**Staff Analysis of Proposed Amendment to the *Dane County*
Water Quality Plan, Revising the
Central Urban Service Area Boundary and Environmental Corridors within the
High Point - Raymond Neighborhood, City of Madison and Town of Verona**

1. Applicant: City of Madison

Map 1
Amendment
 to the Central
 Urban Service Area,
 City of Madison &
 Town of Verona

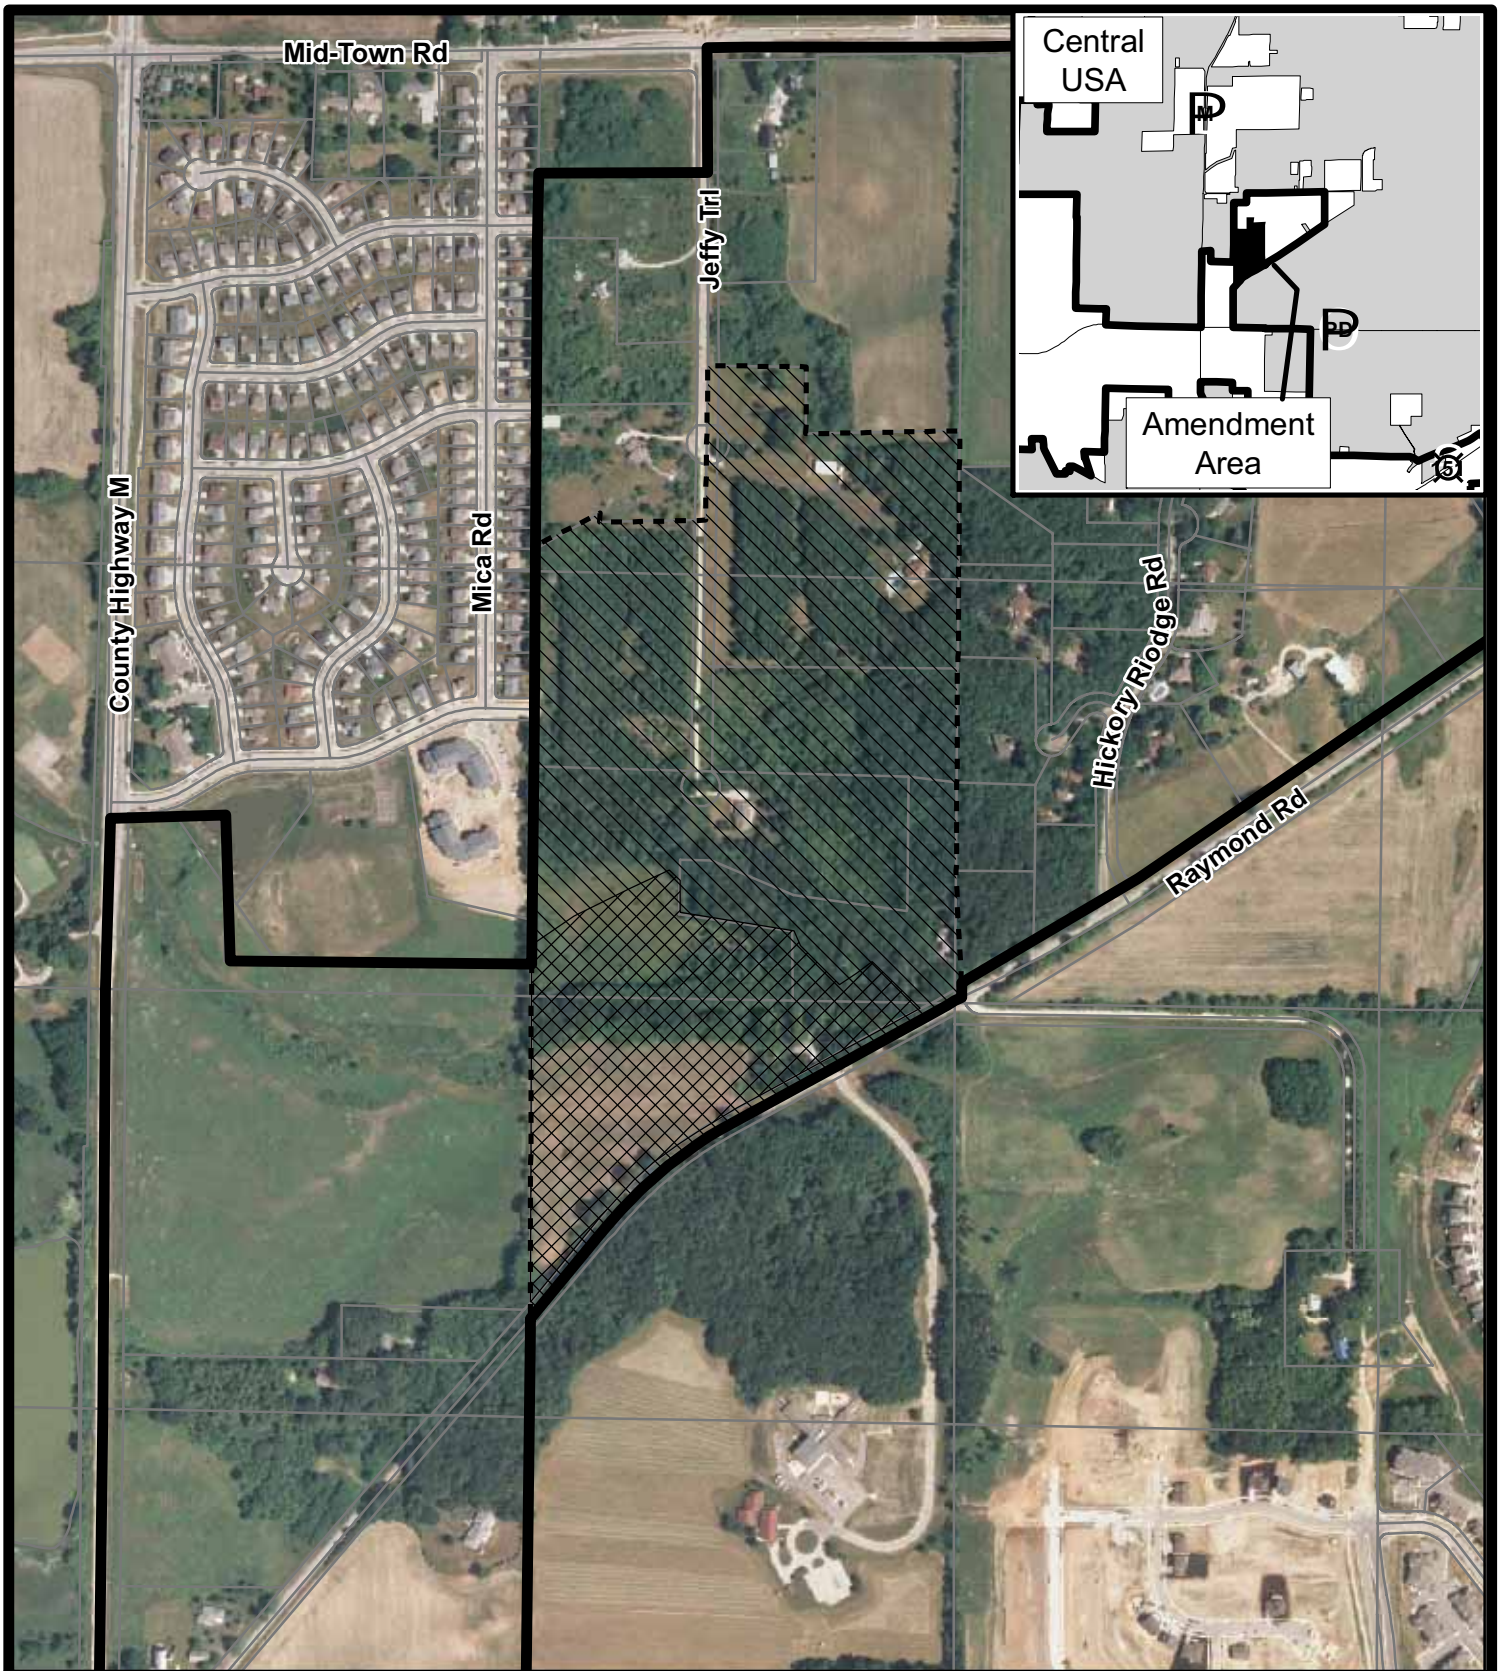
Environmental Corridors. Approximately 17.2 acres proposed for stormwater management, park uses, wetland-shoreland areas and buffers, and open space are proposed for designation as environmental corridors. However, an intermittent tributary of the Badger Mill Creek extends northerly approximately 500 feet beyond what has been proposed for designation as environmental corridors. The WDNR has determined that this tributary is navigable (see Map 5). The minimum criteria for environmental corridors established in the *Dane County Water Quality Plan* would require that all navigable streams and associated 75-foot shoreland buffers (from the top of each bank, or from the ordinary high water mark) to be included in environmental corridors (shown in Map 1 as environmental corridors to be added to the proposal).

- Submit detailed stormwater management plan for the amendment area for CAPD and DCL&WC staff review and approval prior to land disturbing activities. The stormwater management plan should control post-development runoff rates to pre-development rates for all storms up to and including the 100-year storm, protect the water quality of receiving streams, prevent increased erosion, and provide infiltration to the maximum extent practicable (including rear-yard-line infiltration swales and infiltration of rooftop runoff where practicable).
- Include the navigable tributary of Badger Mill Creek (shown on Map 5) and associated 75-foot buffers (from the top of each bank or from the ordinary high water mark), as well as stormwater basins in environmental corridors
